In The Drawings:

REMARKS**Introductory Comments:**

Annotation Marked-up Drawings Application No. 10/707,501

**FIG.1**

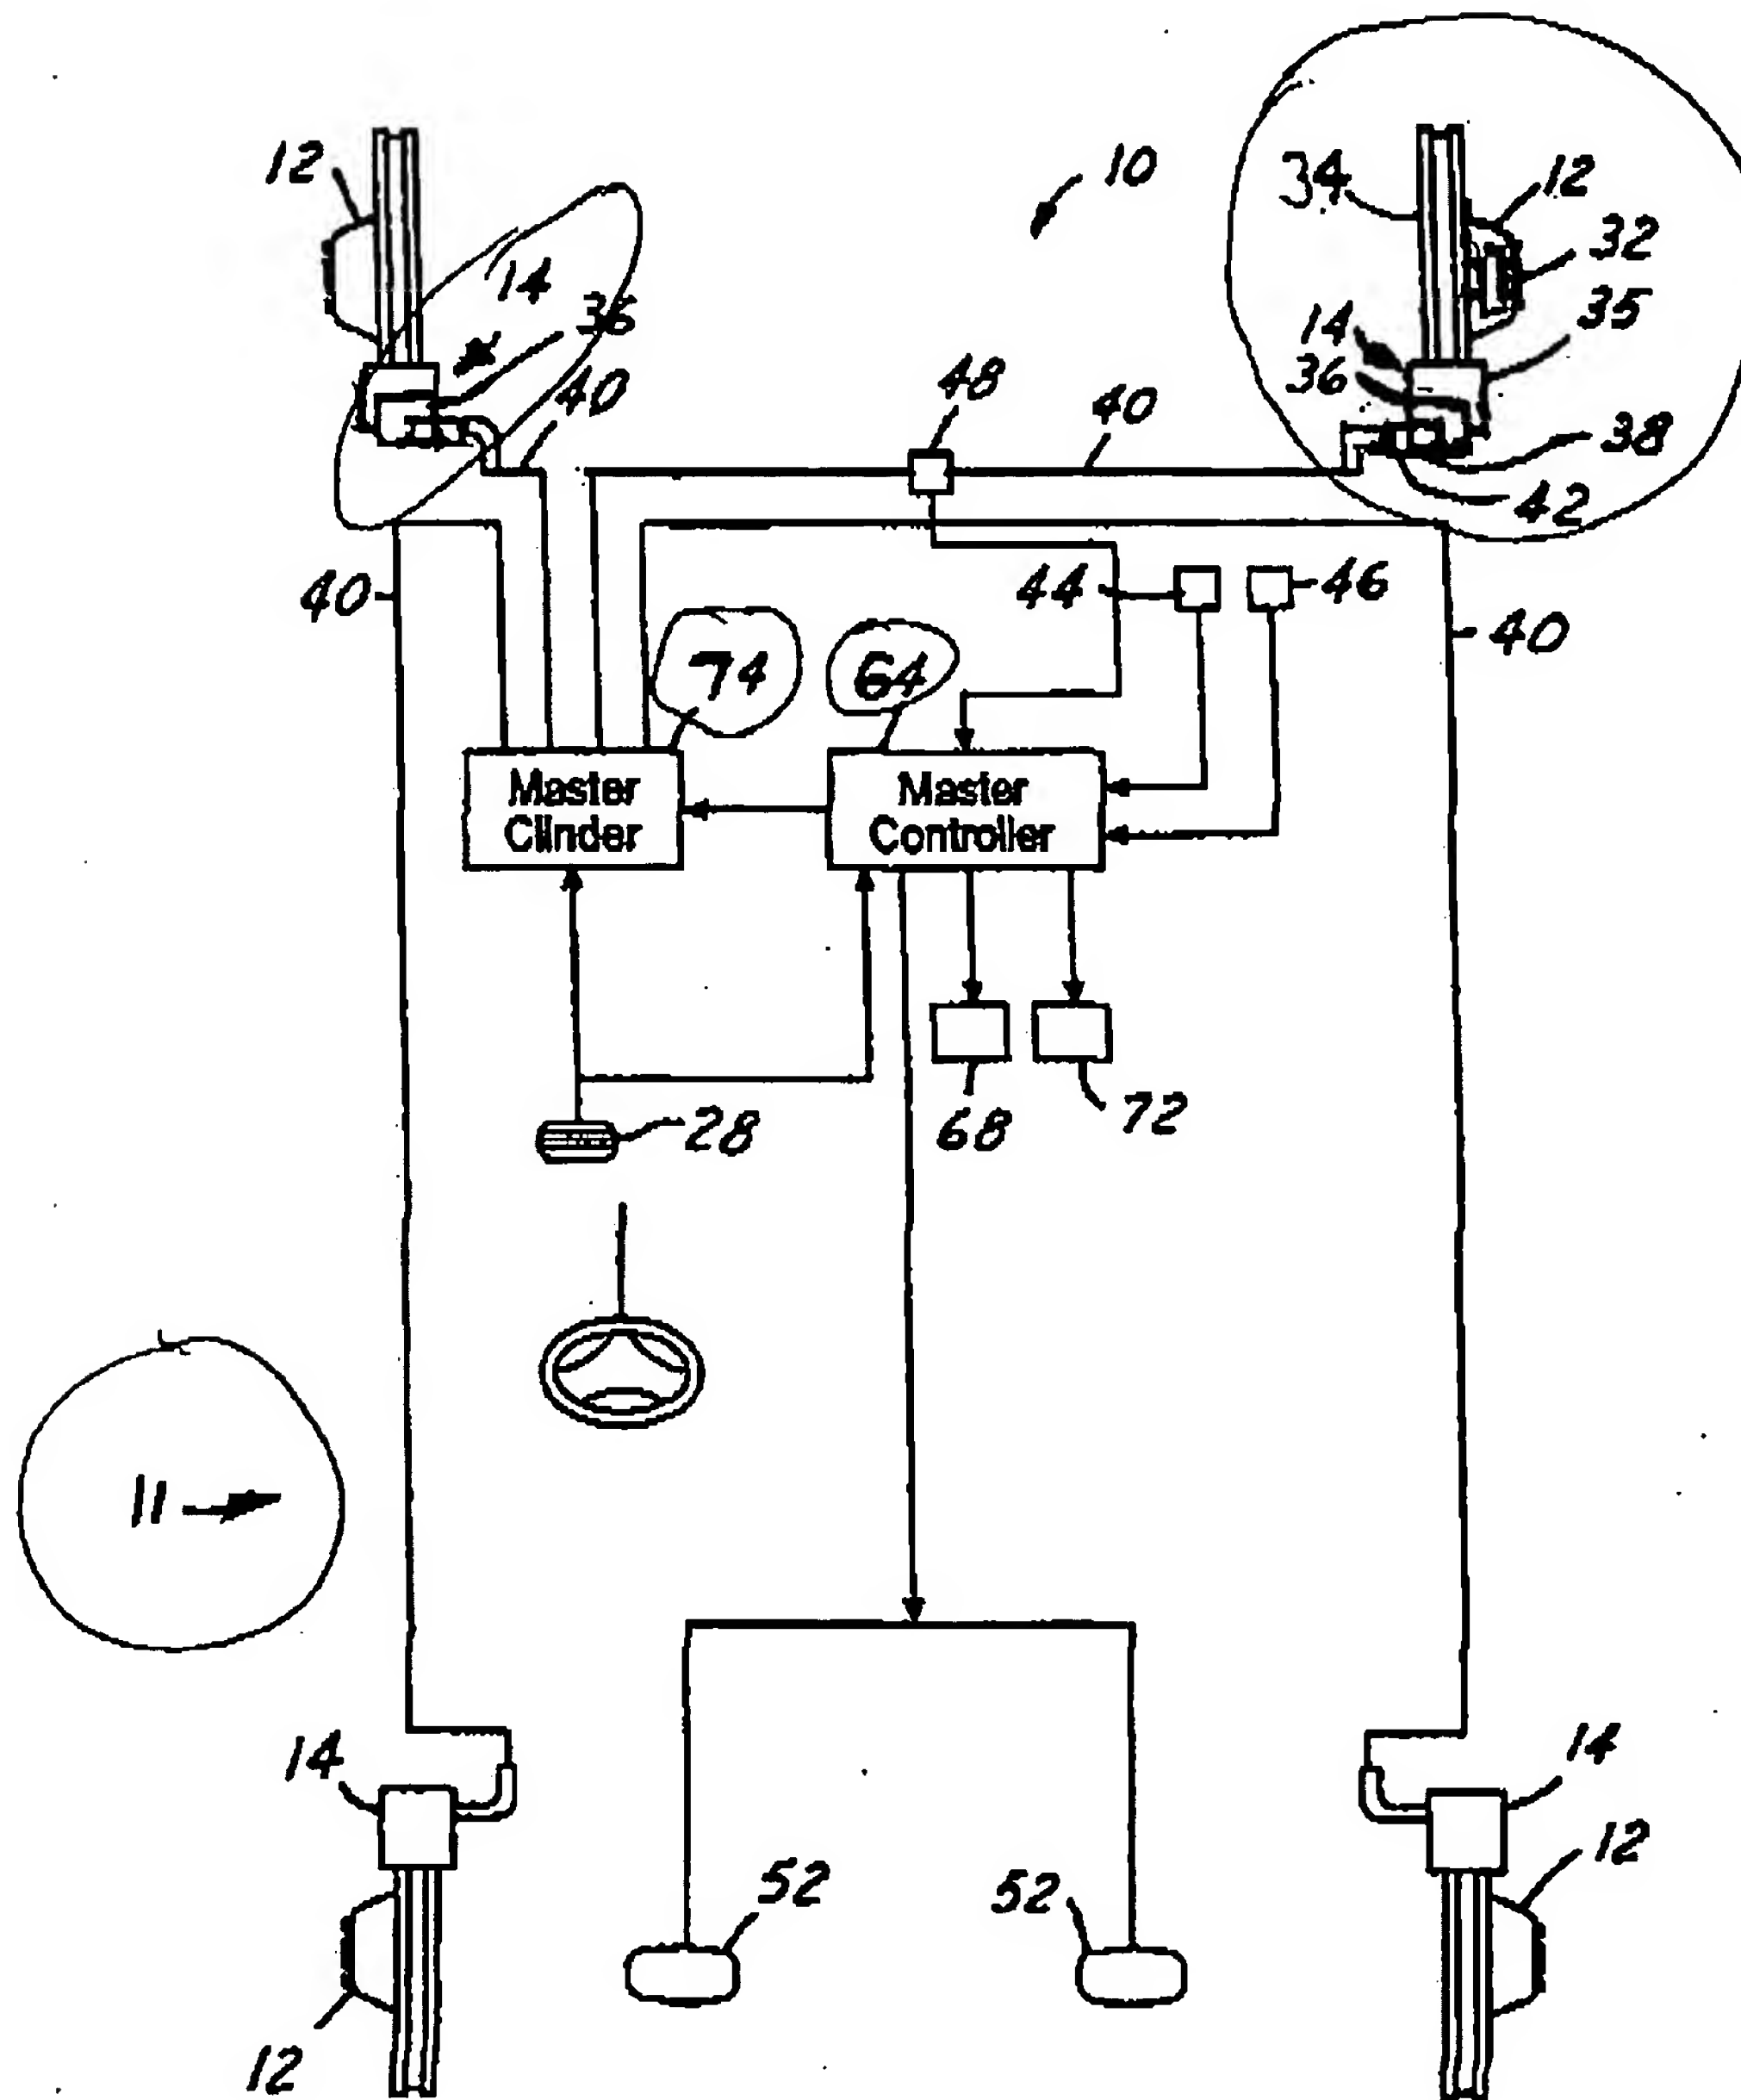
Regarding the drawing objections discussed in paragraph 1 of the Office Action, Applicants have amended the drawings in accordance with the Examiner's suggestions. Further, Applicants have added Figures 1A, 1B, and 1C to illustrate further the components discussed in paragraph 1 in accordance with the description provided in paragraphs [0037] and [0045]. No new matter has been added. Applicants therefore submit one Replacement Sheet containing Figure 1 and one New Sheet of drawings containing Figures 1, 1A, 1B, and 1C.

Regarding the drawing objections discussed in paragraph 2 of the Office Action, as discussed above, the Applicants have added Figures 1A, 1B, and 1C, thereby illustrating the first, second, and third states of the friction component as in claims 1 and 10. Applicants have also added reference to the new Figures in paragraphs [0013] and [0028]. Applicants believe that the matter illustrated in Figures 1A, 1B, and 1C was thoroughly explained in the Detailed Description and the Claims such that one skilled in the art would be enabled thereby. However, Applicants have added the Figures in order to clarify the already present and adequate explanation.

Regarding the drawing objections discussed in paragraph 3 of the Office Action, the Applicants have amended the drawings in accordance with the Examiner's suggestions.

Please substitute the one sheet of drawings submitted herewith containing Figure 1 in place of the originally filed drawing sheet containing the same figure. Also, please add one sheet of drawings submitted herewith containing new Figures 1A, 1B, and 1C.

The Specification is objected to for various informalities. The Applicants respond to the aforementioned objections by amending the Detailed Description of the Preferred Embodiment in accordance with the Examiner's suggestions with the following exception: rather than change all references to "cylinder 74" and "controller 46", Applicants have instead amended Figure 1 such that the specification items (cylinder and controller) are now properly identified in the drawings.
